REMARKS**I. General**

Claims 1-23 are pending in the present application. Claims 1-2, 13-18, and 20-21 stand rejected under 35 U.S.C. § 102. Claims 3-9, 11, 12, 19, 22, and 23 stand rejected under 35 U.S.C. § 103. Claims 1-23 stand rejected under 35 U.S.C. § 112. Claims 2, 14-19, and 22 stand objected to because of informalities. The drawings stand objected to. Applicant respectfully traverses the rejections and objections of record.

FIG. 5
(PRIOR ART)

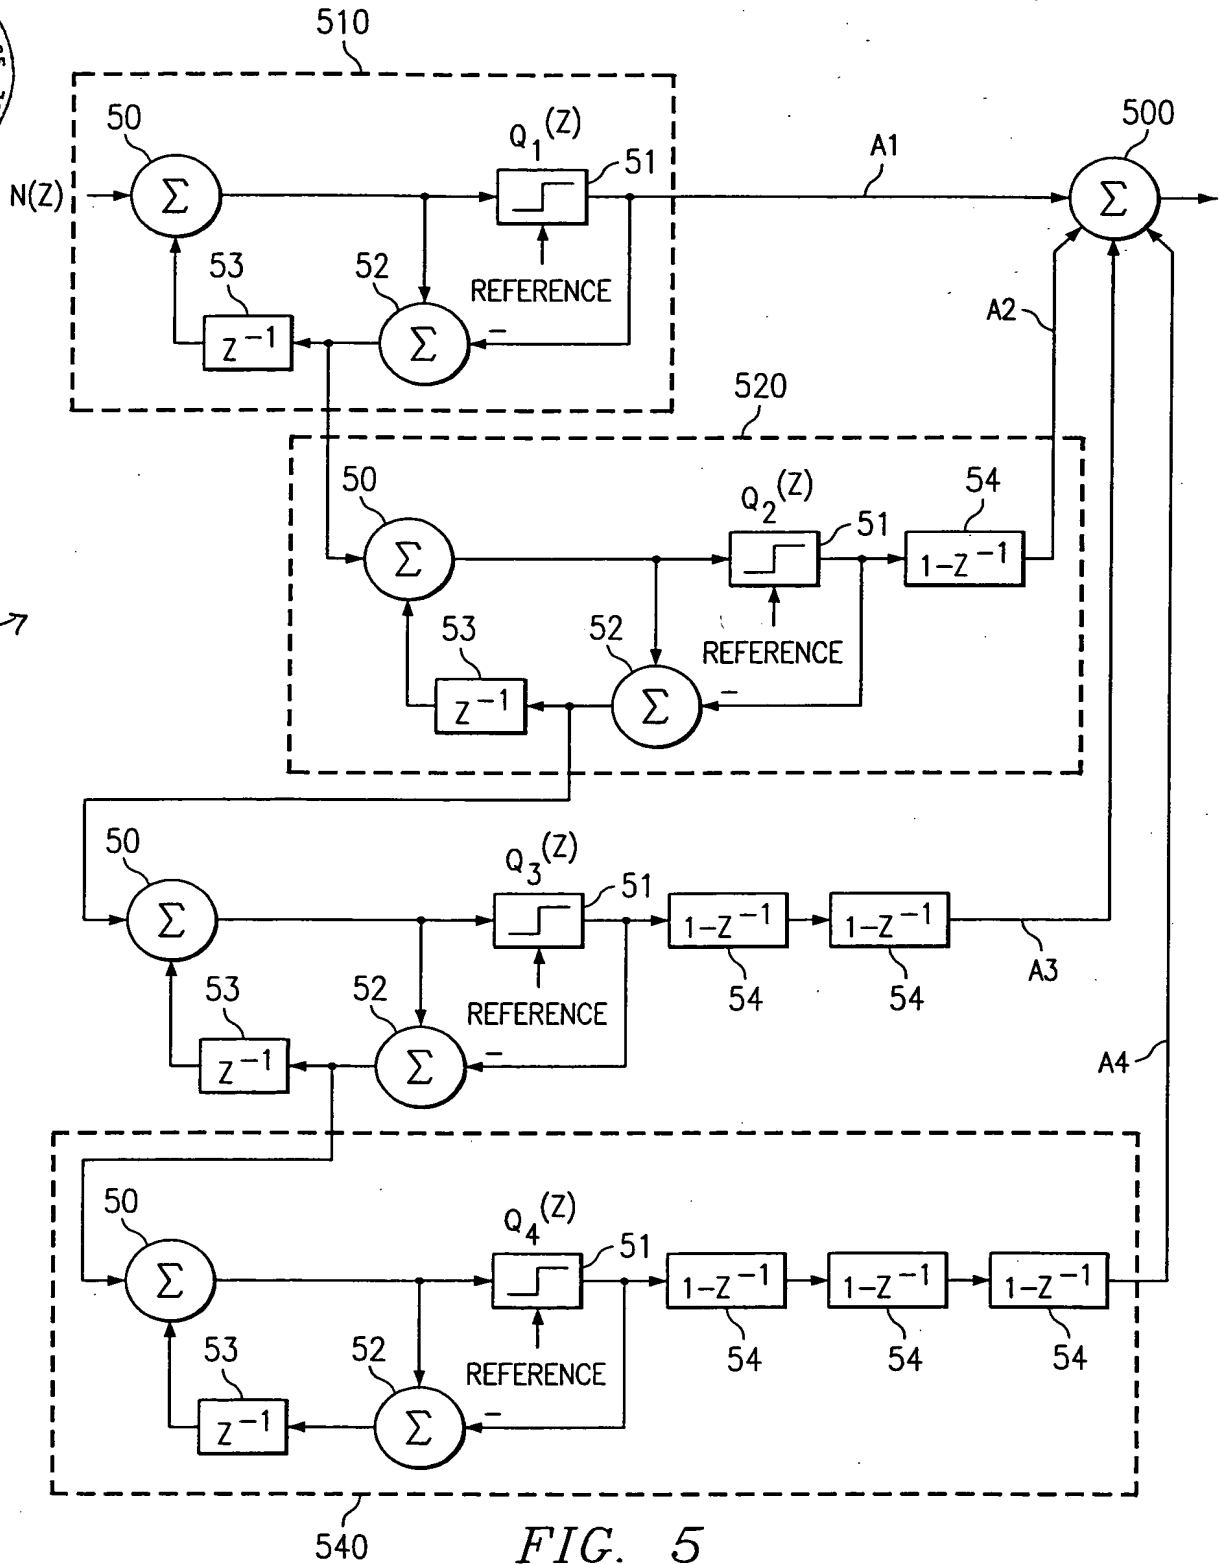
Figure 5 stands objected to as not including reference sign "5" as mentioned in the specification. Applicant submits herewith a proposed drawing amendment adding the reference sign to Figure 5.

FIG. 6

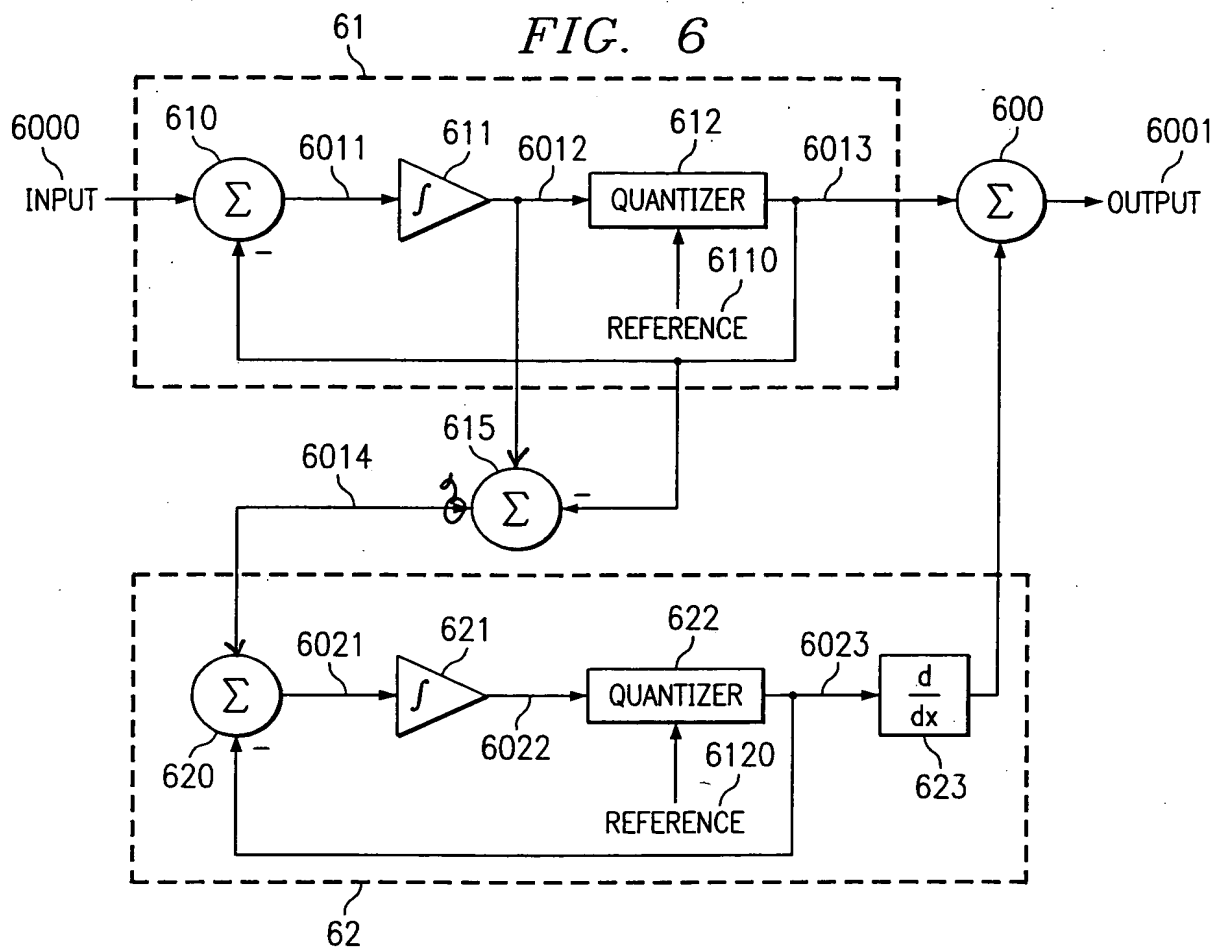
Figures 6, 7, and 8 have been amended to correct informalities discovered during the preparation of the present Amendment. In particular, lines connecting summers 615 and 620 of Figures 6, 7, and 8, summers 735 and 730 of Figures 7 and 8, summers 845 and 840 of Figure 8 included incorrect arrow heads in the formal drawings filed April 16, 2002. These figures have been corrected to correspond with the description provided at page 17, lines 17-25, page 18, lines 5-14, and page 18, line 26, through page 19, line 7. No new matter has been added.

FIG. 8

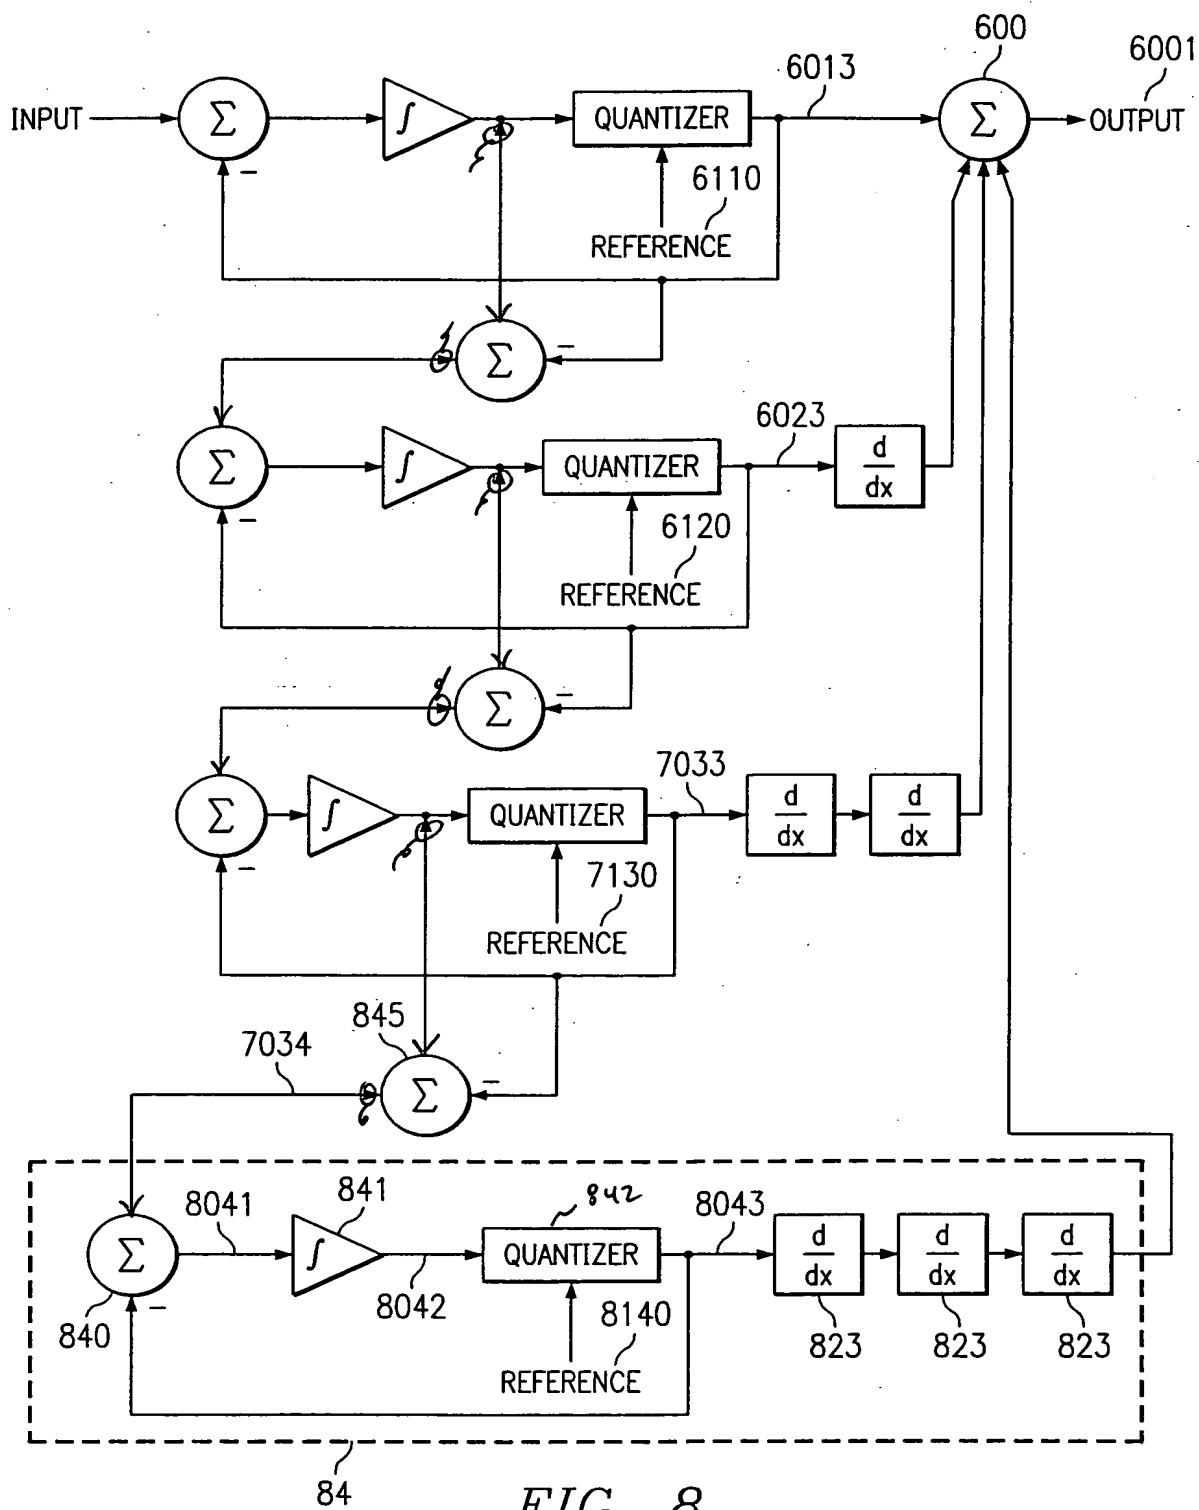
Figure 8 stands objected to as not including the reference sign "842" as mentioned in the specification. Applicant submits herewith a proposed drawing amendment adding the reference sign to the figure.

In rejecting claim 1, the Examiner asserts that the claim recites a set of differentiators disposed in each of said at least one subsequent stage but that Figure 8 shows a second stage which includes one differentiator only. It appears that the source of the Examiner’s consternation is recital of “a set of differentiators” when only one differentiator is shown with respect to a second stage. However, a set, in the ordinary and customary use of that term, can include a single element. As such, the language of claim 1 is fully enabled by the specification.

Figure 8 shows a first delta-sigma modulator comprising a one-stage delta-sigma modulator only. However, the disclosure of Figure 8 is not restricted to the Examiner's characterization of that figure. Figure 6 clearly shows a multi-stage delta-sigma modulator. Additionally, Figure 7 shows a multi-stage delta-sigma modulator wherein a delta-sigma modulator stage has been added to the delta-sigma modulator of Figure 6. Similarly, Figure 8 shows a multi-stage delta-sigma modulator wherein a delta-sigma modulator stage has been added to the delta-sigma modulator of Figure 7. Accordingly, it is clear from these figures that the first two stages of the multi-stage delta-sigma modulator of Figure 8 are themselves a multi-stage delta-sigma modulator and, likewise, the first three stages of the multi-stage delta-sigma modulator of Figure 8 are themselves a multi-stage delta sigma modulator. Accordingly, it is clear from the figures that a characterization Figure 8 is that a first stage thereof comprises a multi-stage delta-sigma modulator. As such, Applicant respectfully asserts that the claim is fully enabled by the disclosure. Moreover, as claim 10 is not rejected over the art of record, Applicant asserts that claim 10 should stand allowed.

In rejecting claim 20 under 35 U.S.C. § 112, first paragraph, the Office Action states that claim 20 recites means for providing the modulated output signal to an output of the multi-order delta-sigma modulator but no additional circuitry is shown other than the summing circuit 600 of Figure 8 for providing the modulated output signal to an output of the multi-order delta-sigma modulator. However, Figure 8 clearly shows output 6001 coupled to summing circuit 600 via a transmission line for providing the modulated output signal to an
